TRINITY PRESBYTERIAN CHURCH

ENVIRONMENTAL IMPACT STATEMENT

TOWN OF HARRISON PLANNING BOARD
TOWN OF HARRISON, NEW YORK

JULY 6, 2015

FIGURE NO. III.C-3

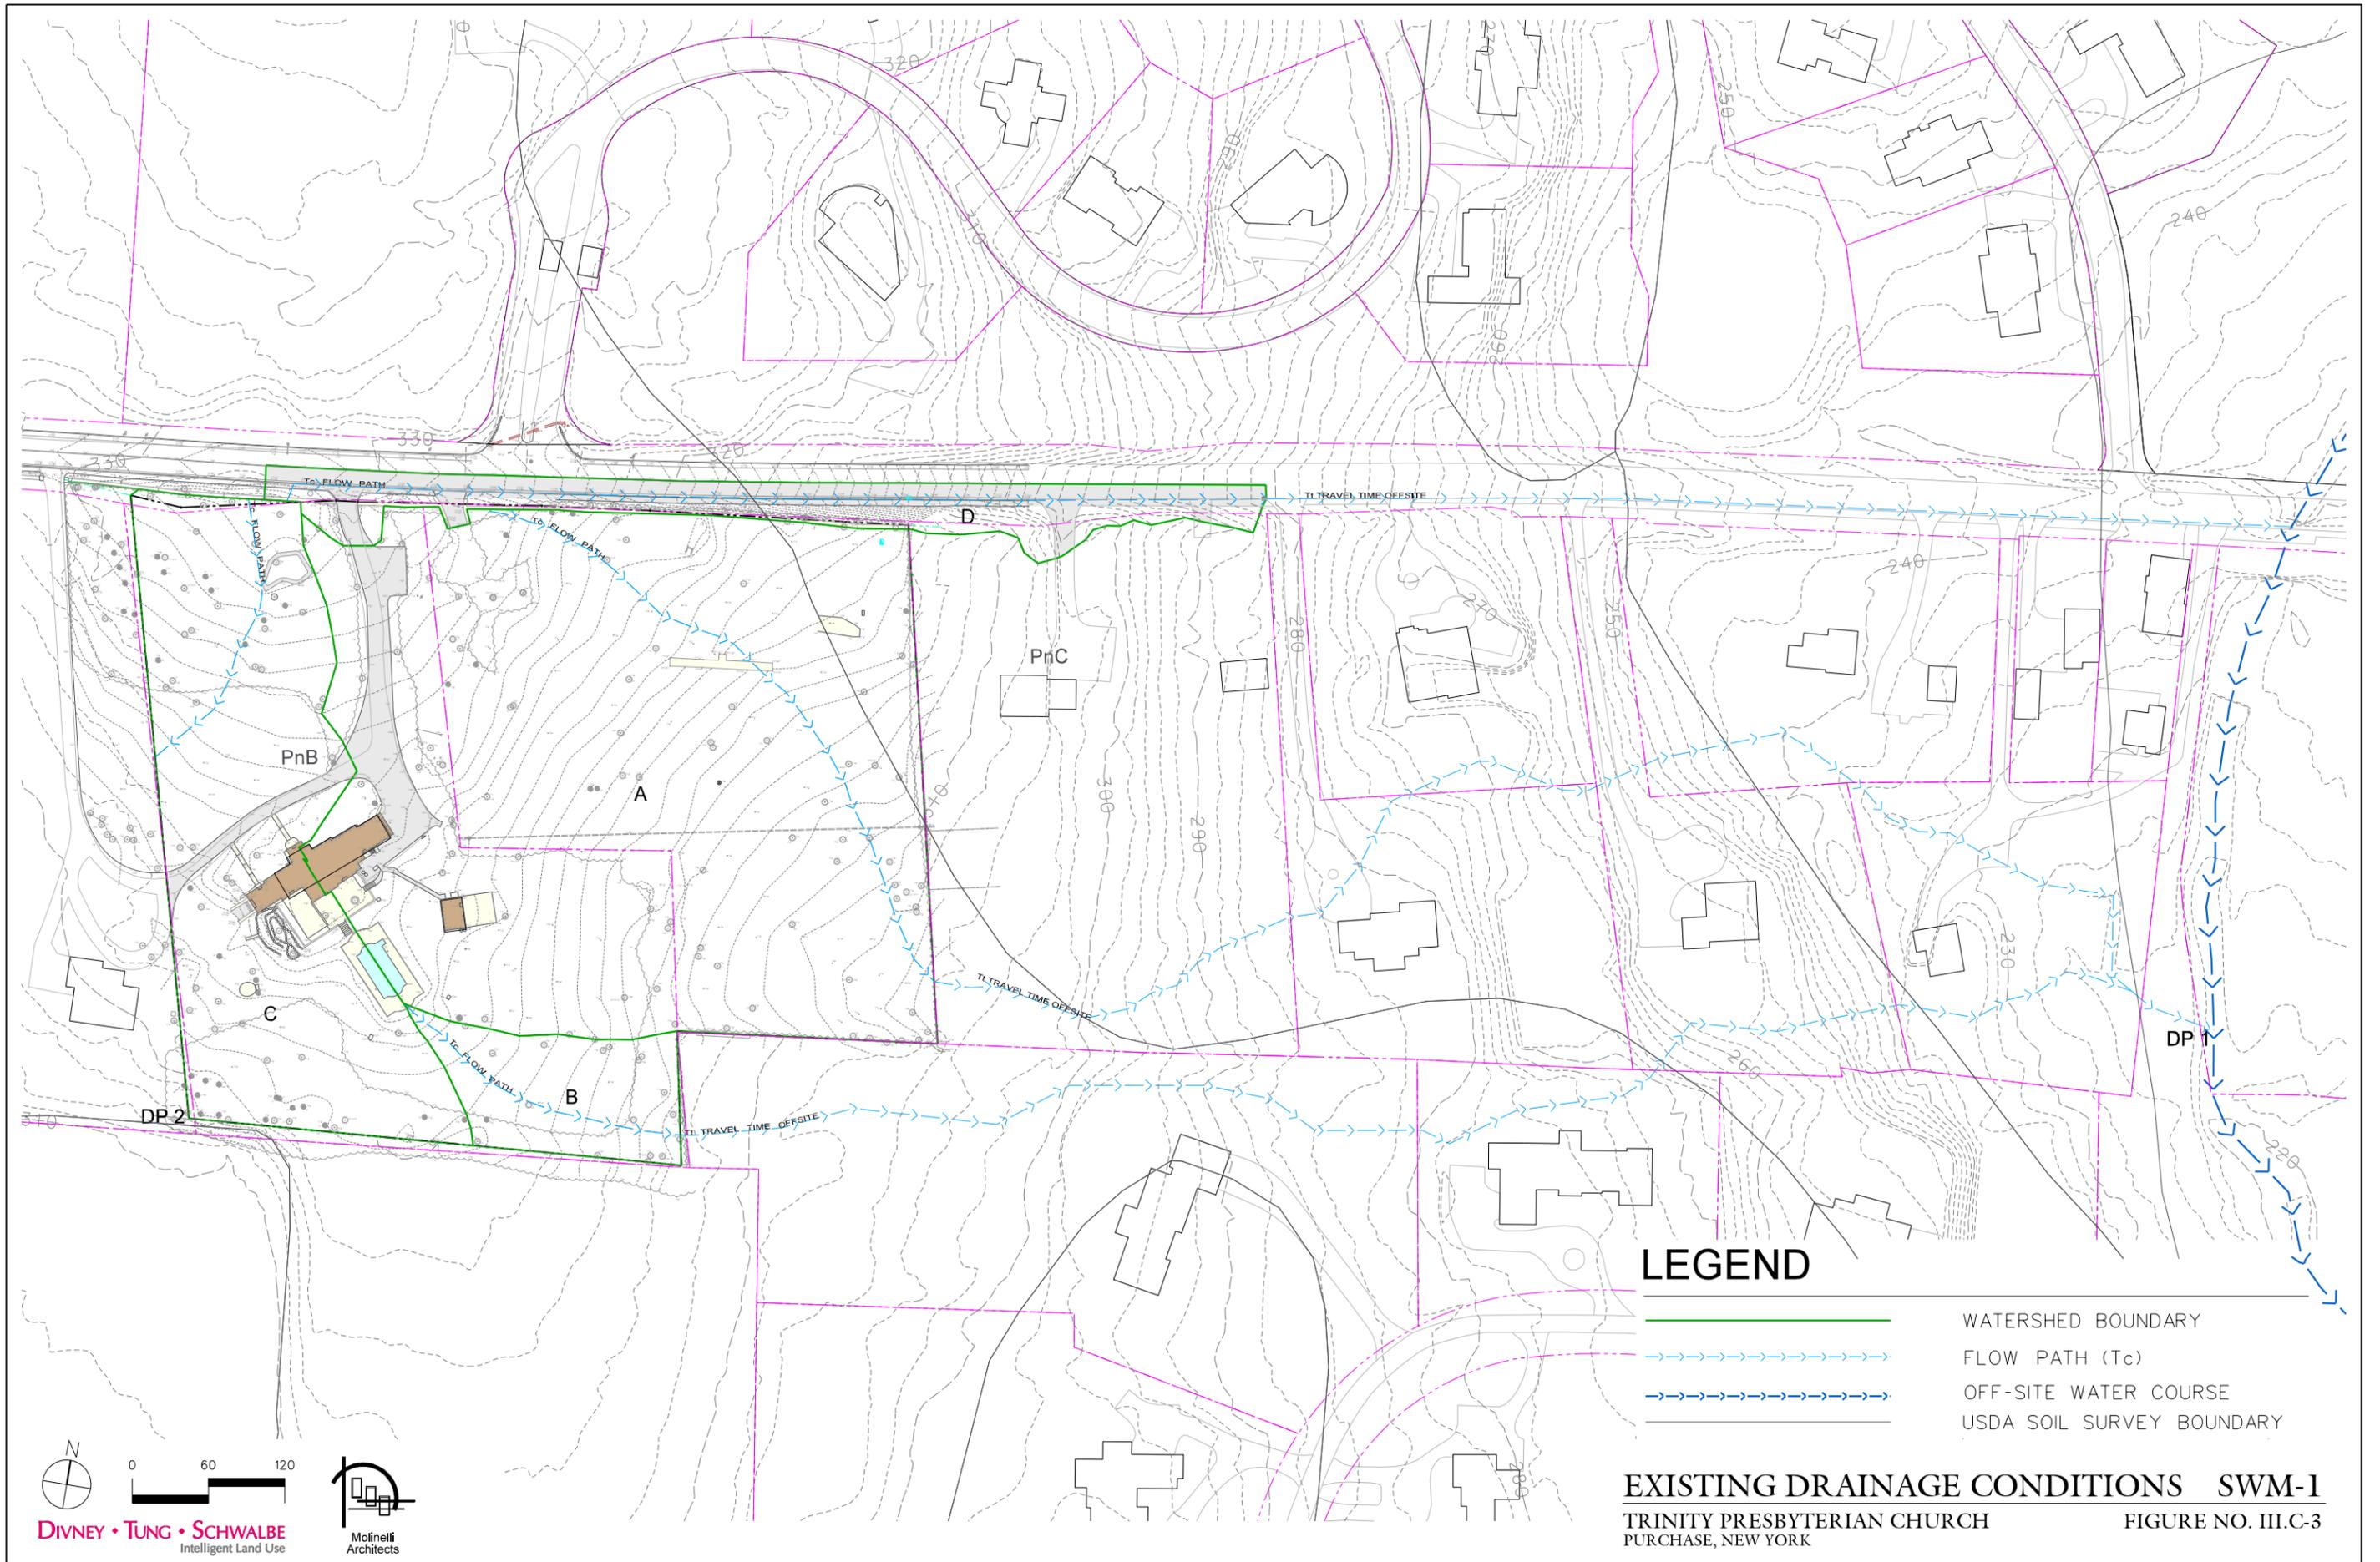
415 Figures III.C-3 and 4 are missing a legend.

PH1612 The drainage figures were entirely unclear to us. We couldn't understand. We assume others have similar questions.

Figure III.C-3 Existing Drainage Conditions and Figure III.C-4 Proposed Drainage Conditions have been revised with legends, and are included at the end of this section.
